Project M-32

SUBJECT: REQUEST FOR DOE DOCUMENTS - WASTE SOLIDIFICATION SYSTEMS
(WSS) ELEMENT (TAC NO. L30616)

SEISMIC / TORNADO ANALYSIS REVIEW FOR THE VITRIFICATION FACILITY AT WEST VALLEY

Figure 4-2. Reprocessing plant and VF elevation (N-S) (Gates, 1993)

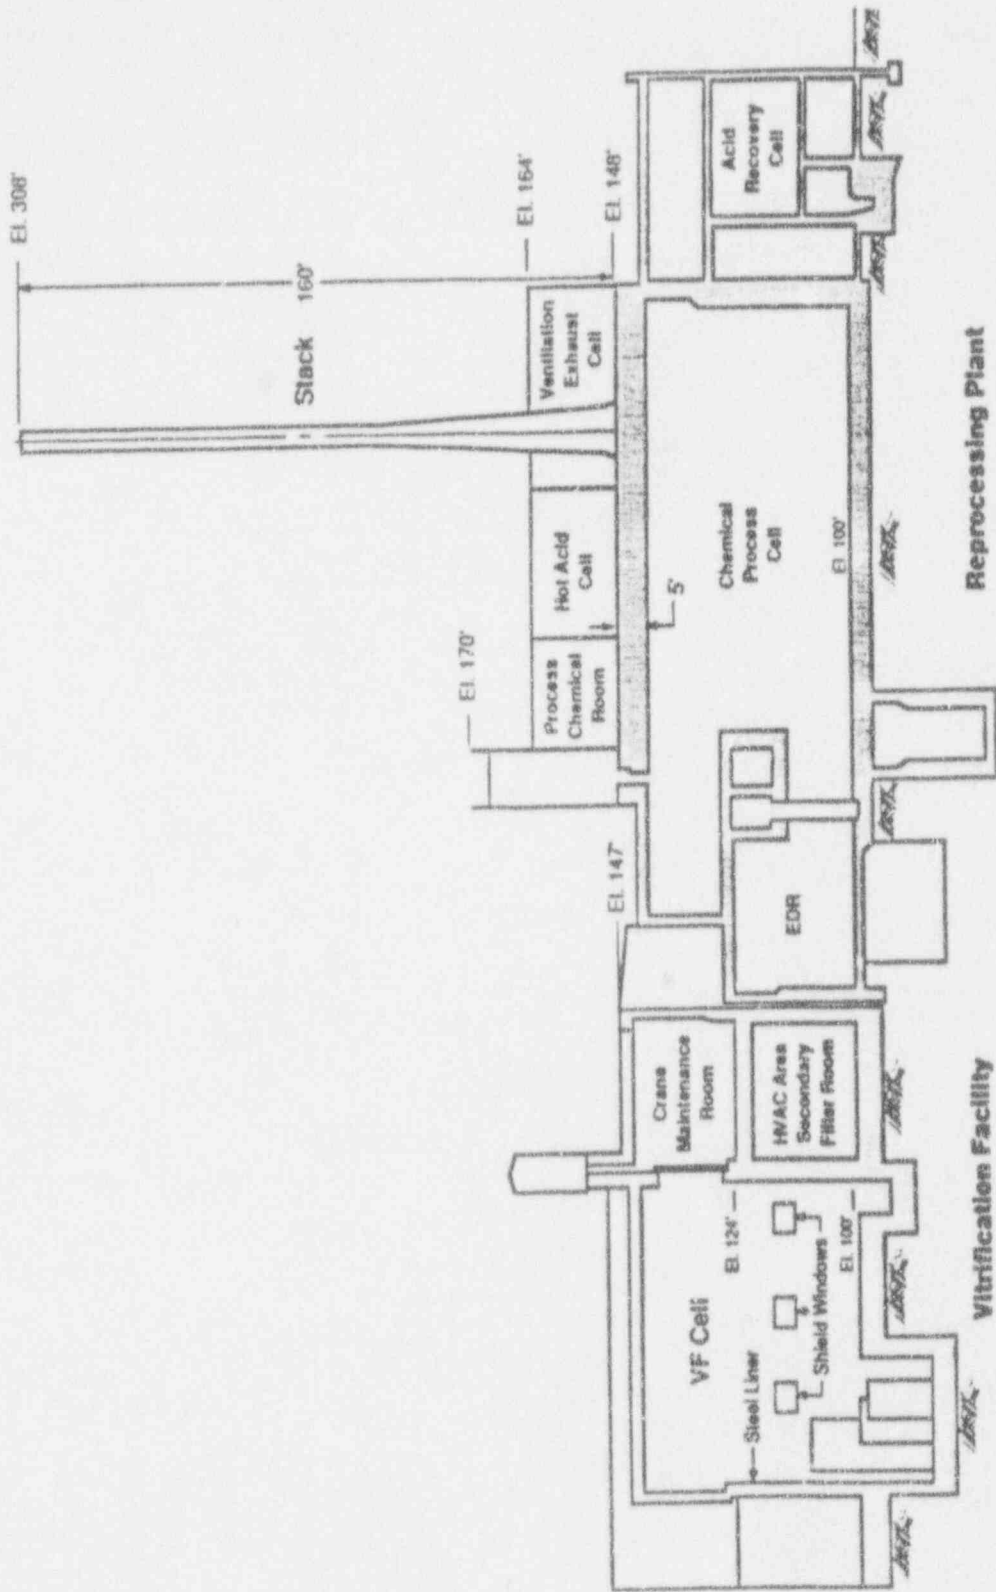
In addition to structural failure, the potential for contact between the VF cell and the Equipment Decontamination Room (EDR) (Figure 4-2) of the existing Nuclear Fuel Reprocessing Plant is determined to be remote. The maximum closure of the existing 3-in. gap is reported to be 0.8 in. Reduction of the soil damping to 10 percent could increase the deflection by a factor of 2 with a corresponding reduction in the margin of safety. The model utilized for this analysis is given in Figure 3-5. It basically consists of the VF stick model coupled to another stick model of the EDR.

In addition to structural failure, the potential for contact between the VF cell and the EDR of the existing Nuclear Fuel Reprocessing Plant (Figure 4-2) was calculated. The separation between the VF and the EDR during the seismic events is based on modeling the response of the building under the

influence of traveling seismic waves combined with the dynamic response of the buildings. This analysis showed a maximum of 0.8 in. closure for a total gap of 3 in., giving an acceptable margin of safety. Reduction of the soil damping to 10 percent could increase the deflection by a factor of 2, with a corresponding reduction in the margin of safety.

Figure 5-1. Horizontal design response spectra from RG 1.60 and ASCE No. 58 (RG 1.60)

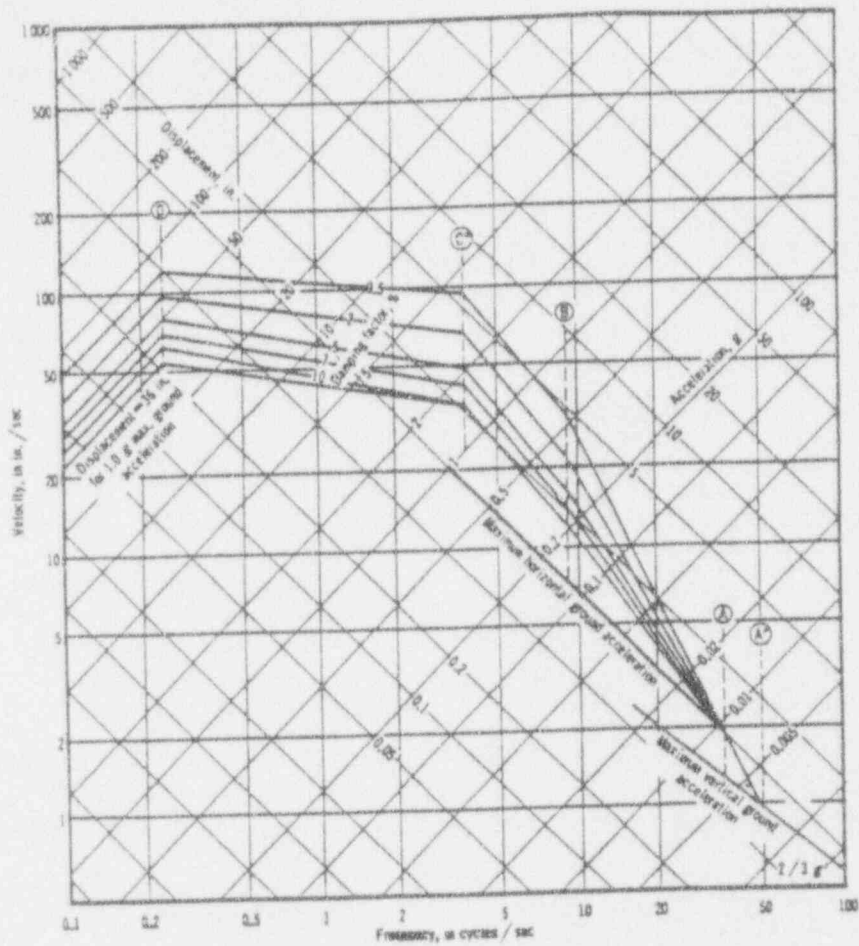
- (i) Definition of the DBE seismic event is in terms of the peak acceleration value and the associated response spectra tailored to the WVDP site needs to be justified. Currently, all analysis is based on a deterministic approach using a RG 1.60 spectra normalized to a 0.1 g peak acceleration. From the presentation (Gates, 1993), it appears that a 10 percent margin was applied to the peak acceleration for all analysis, to account for statistical variations between time histories. This is consistent with current practice for equipment. The issue is whether the peak acceleration level is appropriate for the WVDP site. As indicated earlier and based on a probabilistic approach and expert opinions (Bernreuter et al., 1989), sites in the region may have seismic events with a peak acceleration of 0.14 (rock) to 0.21 (deep soil) g. Note that these are mean values while the RG 1.60 specification is associated with the mean plus one standard deviation.

It is important to define the peak acceleration levels and response spectra for both the horizontal and vertical spectra that are consistent with the expected events in the region. This tailoring process is consistent with current NRC practice and should be carried out for this plant.

A large amount of analysis has been performed based on the 0.1 g levels and the RG 1.60 horizontal and vertical spectra (Figures 5-1 and 5-2). It is not necessary to re-analyze based on any updated level. For linear analysis, it is possible to apply a correction factor and develop new margins of safety for the seismic event. An additional factor that needs to be taken into account is the expected life of the plant, 5 years. This is less than the typical 30 to 40 years of a power plant and will influence the final determination of the overall margins of safety.
